Bid Bulletin No. 6
 August 27, 2020

PUBLIC BIDDING No. 20 – 022– 3

**CONSTRUCTION OF ASCOM FACILITIES AT CAMP AQUINO, TARLAC
 FOR THE BASES CONVERSION AND DEVELOPMENT AUTHORITY**

TYPICAL COLUMN ELEVATION & SCHEDULE

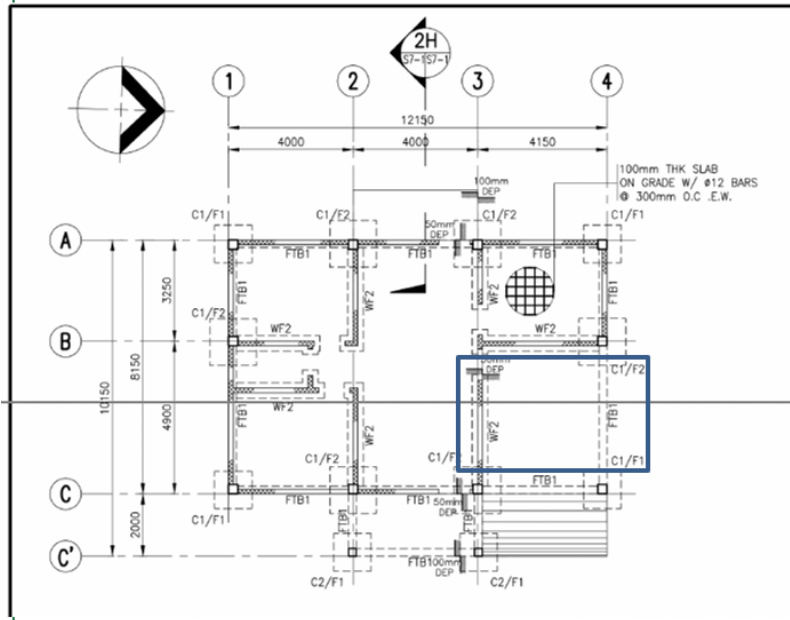
S29-2

Verify number of sets of Column ties of C2A & C2, discrepancy to given drawings, which will govern

All columns should have a set of three (3) ties.
